From: [Kalyanam, Kaly](#)
To: [CLARK, ROBERT W](#)
Subject: RAI for the Request to use of Alternate ASME Code Case N-770-1 Baseline Examination, Request for Alternative ANO2-ISI-007. (TAC No. ME7646)
Date: Tuesday, August 28, 2012 11:55:00 AM
Attachments: [RAI fro EPNB RAI 08-21-12.pdf](#)

OFFICE OF NUCLEAR REACTOR REGULATION
REQUEST FOR ADDITIONAL INFORMATION
USE OF ALTERNATE ASME CODE CASE N-770-1 BASELINE EXAMINATION
ENTERGY OPERATIONS, INC
ARKANSAS NUCLEAR ONE, UNIT 2
DOCKET NUMBER 50-368

Figure 1 Top View of 2D Matrix Array Depicting Separation Dimension

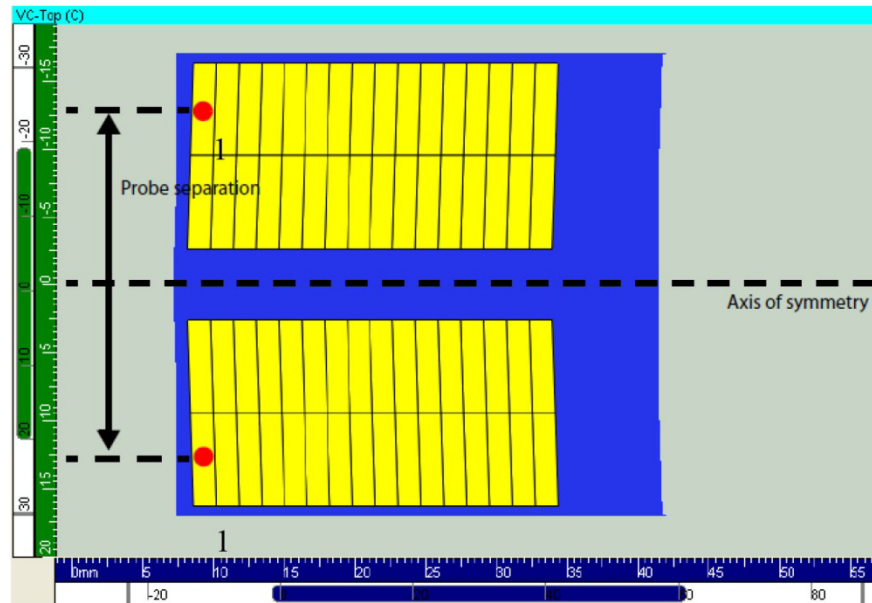
- 2. Longitudinal (L) and/or shear (S) wave
 - iii. Array configuration (matrix)
 - 1. Whether identical or different transmit-receive arrays, if used
 - 2. Physical separation between arrays (if TRL/TRS configuration). Identify distance between first element of one array and first element of second array (array separation – see Figure 1)

Figure 2 Top View of 2D Matrix Array Depicting Primary and Secondary Axis Pitch Dimensions

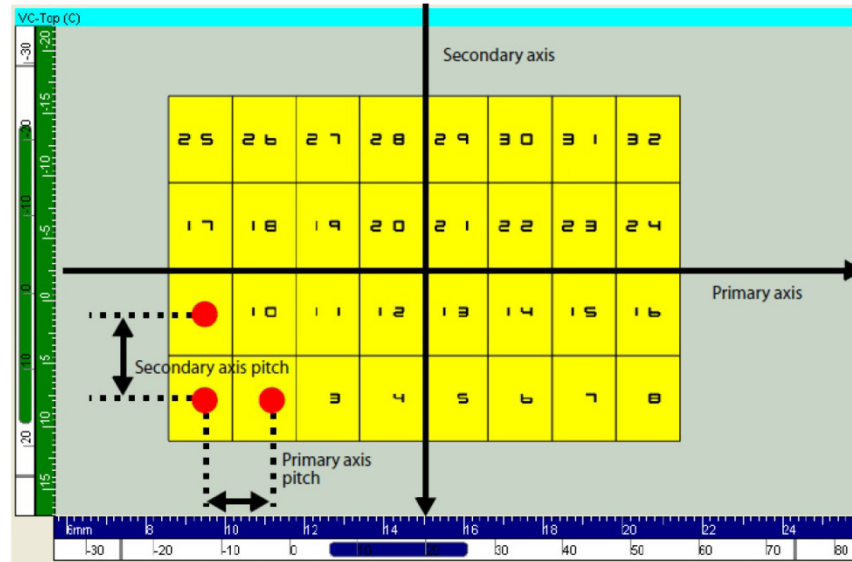
- 2. Number of elements along the secondary axis
 - v. Element dimensions along primary and secondary axes, spacing between elements, and center-to-center distance (pitch – see Figure 2)

Figure 3 Definition of Wedge Angle

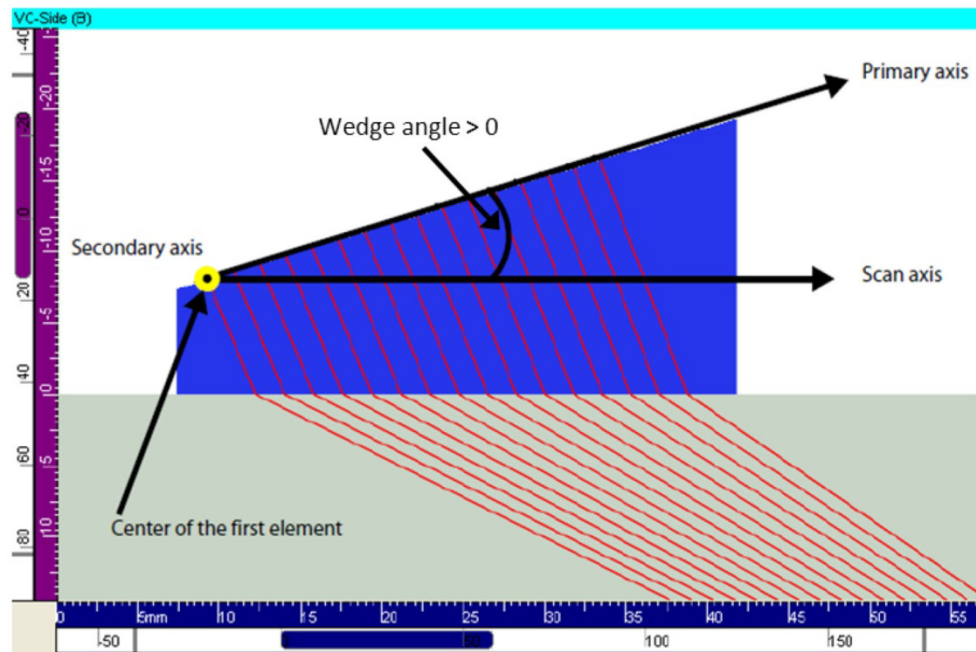
- b. Wedge (see Figure 3)
 - i. Material type – Rexolite, other, etc.

1. Longitudinal and shear wave velocity
2. Attenuation (if known)
3. Density (if known)
- ii. Geometry
 1. Wedge angle
 2. Roof angle (if used)
 3. All physical dimensions necessary to create 3-D solid model, such as height at front of wedge, height at back of wedge, width of wedge, and length of wedge

4. Placement of each probe on each wedge; i.e., what is the height of the middle of the first element?
 5. Is wedge contact geometry contoured to the specimen? If not, what contour does it have, if any?

Figure 4 Beam Focusing Options for Phased Array Probes

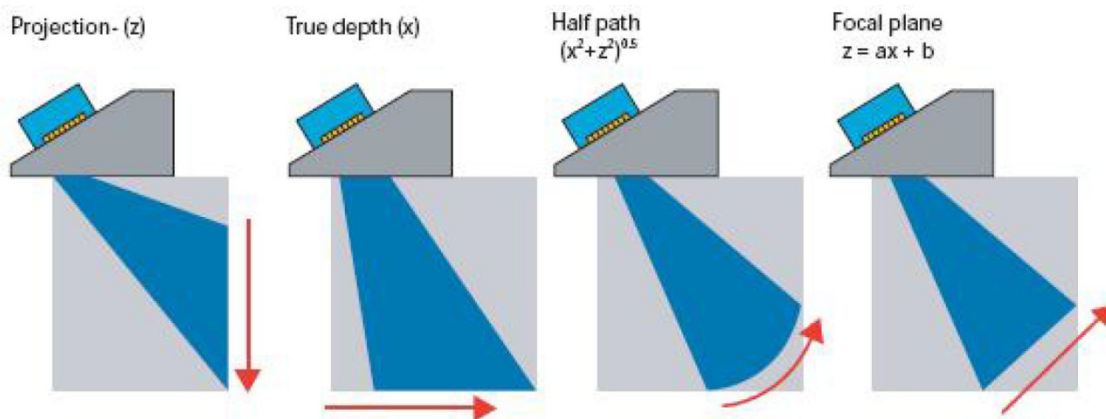
- c. Beam focusing
 - i. Please state the type of focusing used and include associated details, as listed below. The four types of focusing techniques are listed below and shown graphically in Figure 4.

1. *Projection* – focusing in a specific vertical plane
 - a. Parameters: distance from probe reference point, sweep angles (start, stop, interval), skew angle(s)

2. *True depth* – focusing at specific constant depth with all angles focused at this depth
 - a. Parameters: focusing depth, sweep angles (start, stop, interval), skew angle(s)

3. *Half-path* – sound path held constant as beam is swept
 - a. Parameters: sound path length, sweep angles (start, stop, interval), skew angle(s)
 4. *Focal plane* – arbitrary user-defined plane of focus

- a. Low angle path length, high angle path length, sweep angles (start, stop, interval), skew angle(s)
 - ii. Number and configuration of elements used in data acquisition (active aperture), if different than total number of elements within each probe (e.g., if a linear array probe physically contains 64 elements but only the first 32 were active – this needs to be defined)
